## PRODUCT/PROCESS CHANGE NOTICE (PCN)

PCN #: <b>L-0607-01R1</b> Product Affected: <b>Please see the attached list of the affected products shipped in tape and reel, and in tubes</b> Date Effective: <b>6-Oct-06</b>	DATE: <b>6-Oct-06</b>	MEANS OF DISTINGUISHING CHANGED DEVICES: <input type="checkbox"/> Product Mark <input type="checkbox"/> Back Mark <input checked="" type="checkbox"/> Date Code <input type="checkbox"/> Other Lot shipments will have Level 1 Moisture Sensitive Label, and with date code starting "0630".
---	-----------------------	---

**PCN Type:** Change in Moisture Sensitivity Level

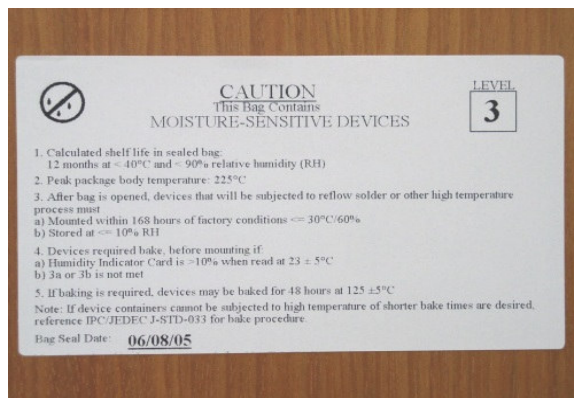
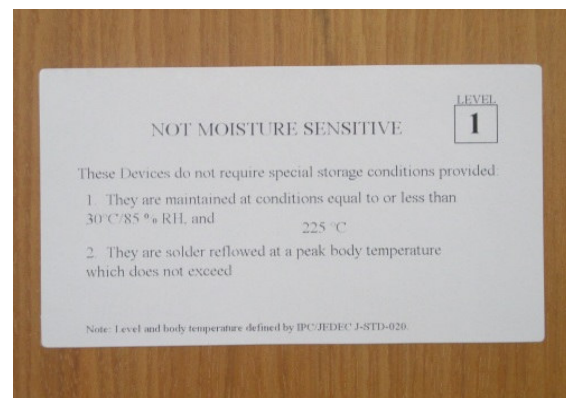
This notification is to advise customers that IDT is converting ICS MSL 3 products shipped in tape and reel, and in tubes, to MSL 1. IDT has completed the verification of the moisture sensitivity classification of ICS products to MSL 1.

The affected products will be shipped without dry pack and labelled as MSL 1 according the JEDEC J-STD-033. There is no change to the assembly material set and the peak reflow temperature. Please refer below for the examples of moisture sensitive labels.

**From: MSL 3 Moisture Sensitive Label**

**To: MSL 1 Non-Moisture Label**

**Note: There is no change to the peak reflow temperature of the affected products.**
